Access Report for Charters Towers

Charters Towers QLD 4816

**A report by:
John Mayo
Access Solutions
109 Logan Rd
Woolloongabba 4102
Phone: (07) 3391 2044
Fax: (07) 3391 2088**

Photo 28

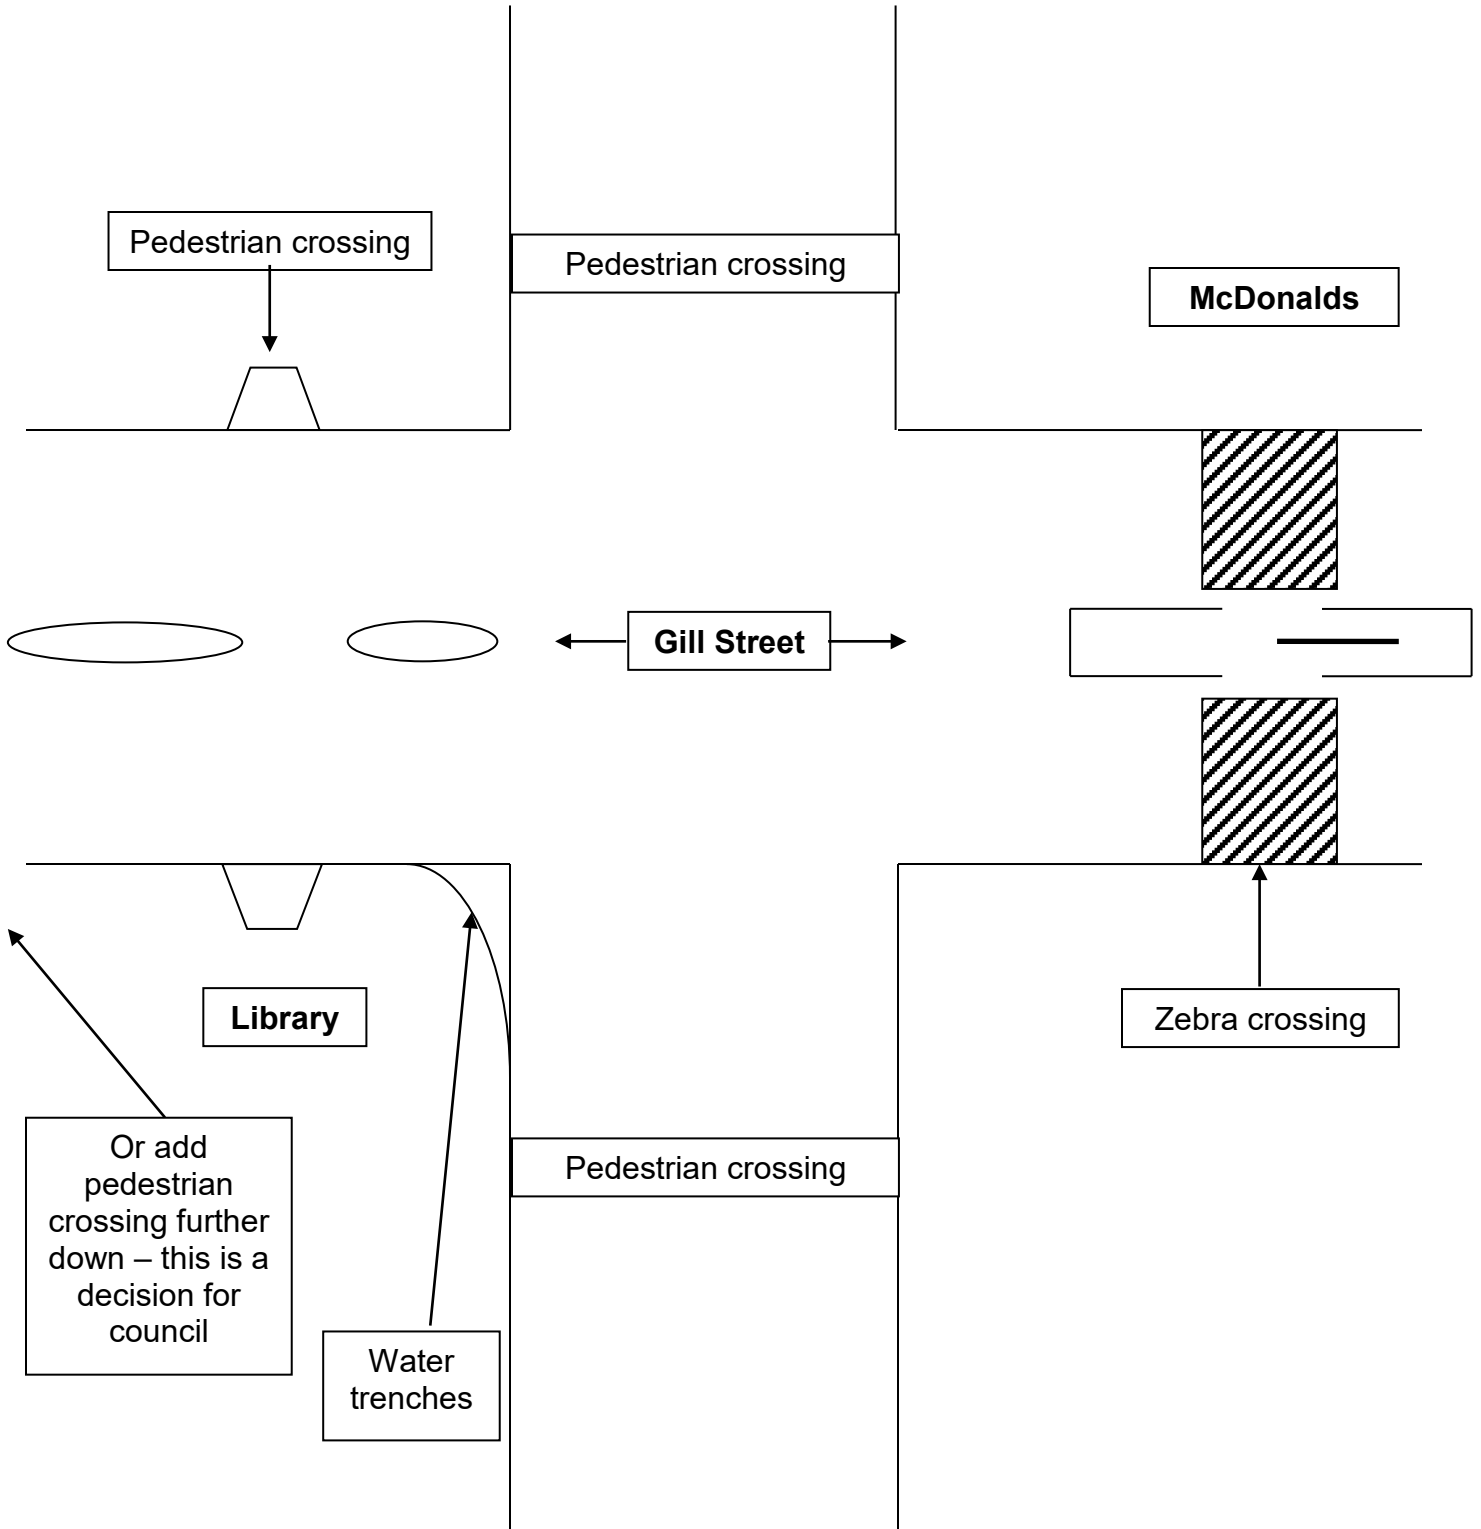
The existing McDonalds kerb ramp is just as bad as its counterpart across the road. A flat wide transition should be easy to achieve. In that case install Hazard Tactile Ground Surface Indicators. AS1428.4
